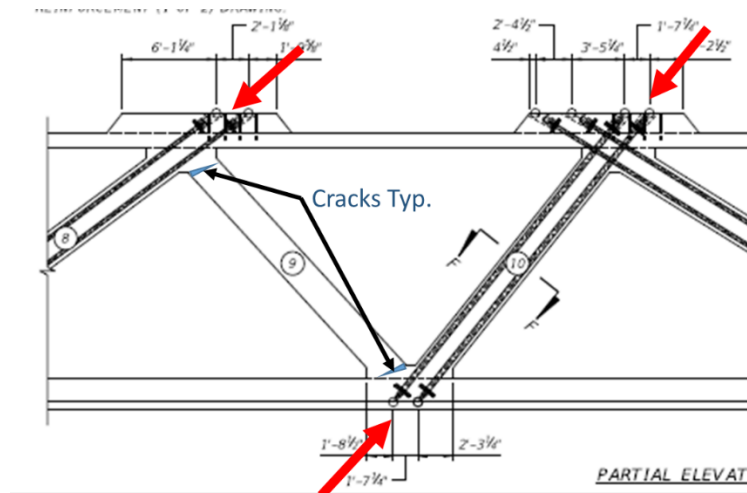
B-38 and B-109 Stage 2, Step 2: During the stressing of the PT bars in Stage 2, Step 2, there is a concern with cracking the adjacent members that are not yet stressed or adjacent members that are not post-tensioned. The temporary stress check needs to account for the rigidity of the joints.

- a. B-109 Stage 2, Step 1.B: Are only vertical and diagonal members with PT bars to be cast? If so, when are the other members to be cast? Clarify intent.
- b. B-109 Stage 2, Step 2:
 - i. Clarify what is intended for vertical versus diagonal members.
 - ii. Clarify what order to stress members to minimize cracking of adjacent members. Consider stressing members in the order from the most-vertical to the least-vertical.
 - iii. There is a concern with cracking in adjacent members prior to longitudinal PT that are not PT'ed. See sketches below:

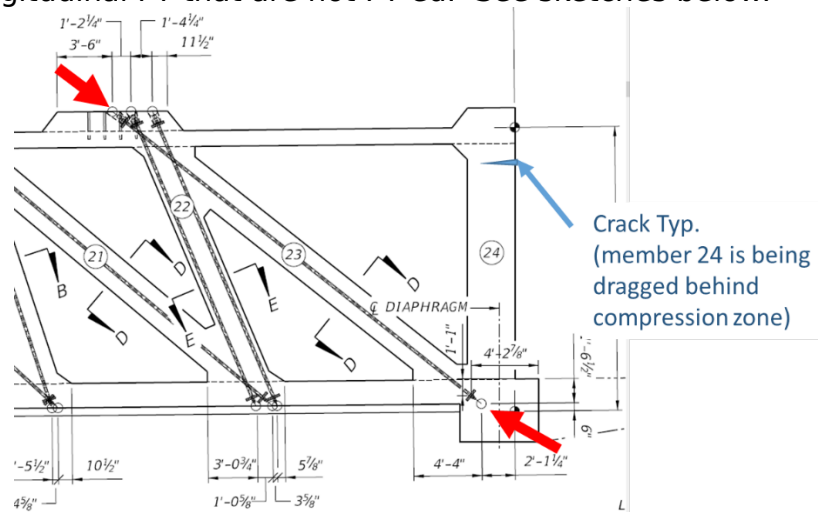
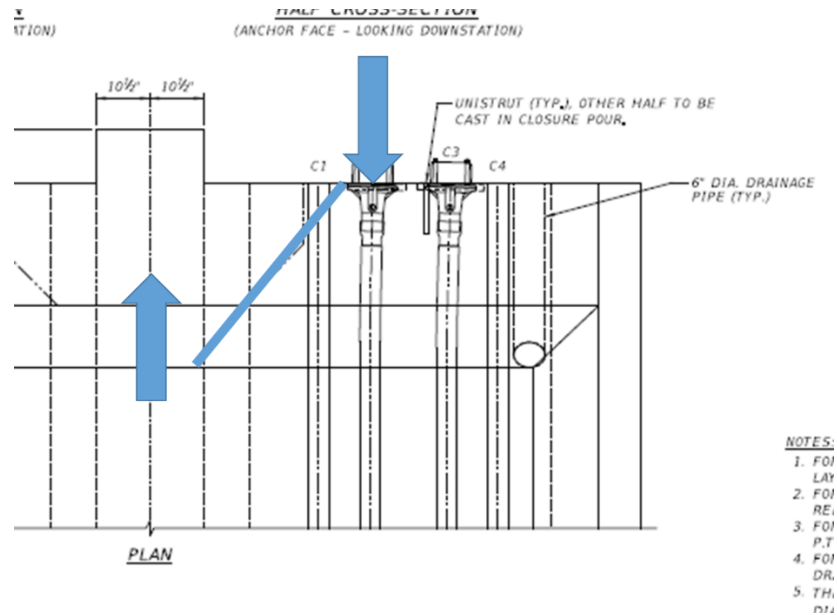
B-42, B-109 Stage 5, Step 5: During the stressing of the PT bars in Stage 5, Step 5, there is a concern with cracking the adjacent members that are not yet stressed or adjacent members that are not post-tensioned. The temporary stress check needs to account for the rigidity of the joints.

- i. Clarify what order to stress members to minimize cracking of adjacent members. Consider stressing members in the order from the most-vertical to the least-vertical.
- ii. There is a concern with cracking in adjacent members prior to longitudinal PT that are not PT'ed. See sketches below:

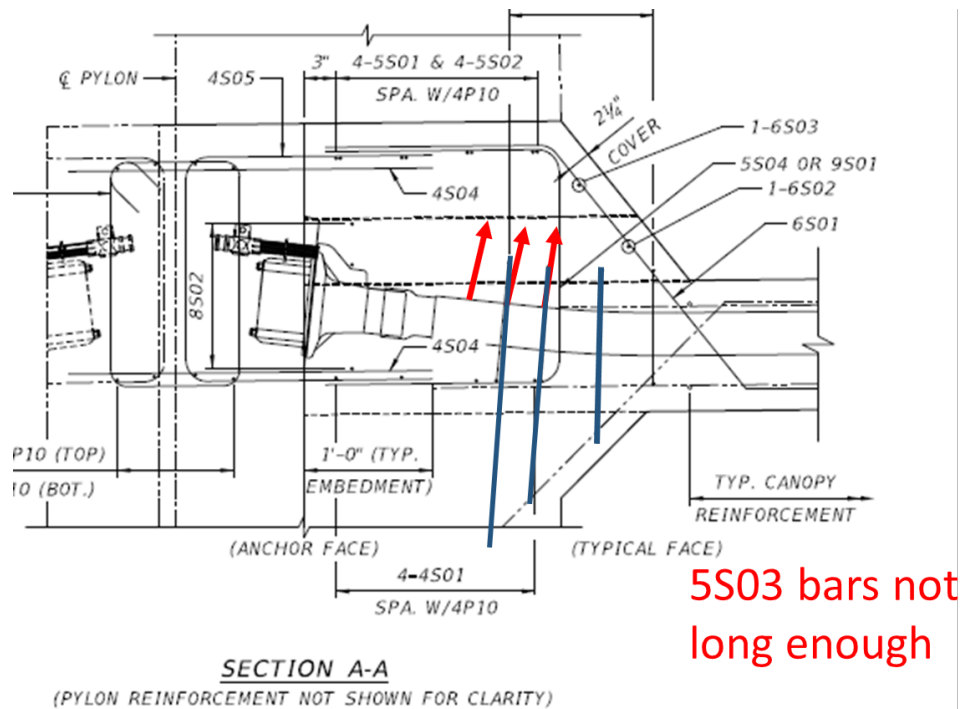
B54 thru B-59: There is still a concern that without transverse PT of canopy end diaphragms that cracking will develop during longitudinal PT stressing. The concern is the web section which will get dragged behind the compression zone. See sketch below.
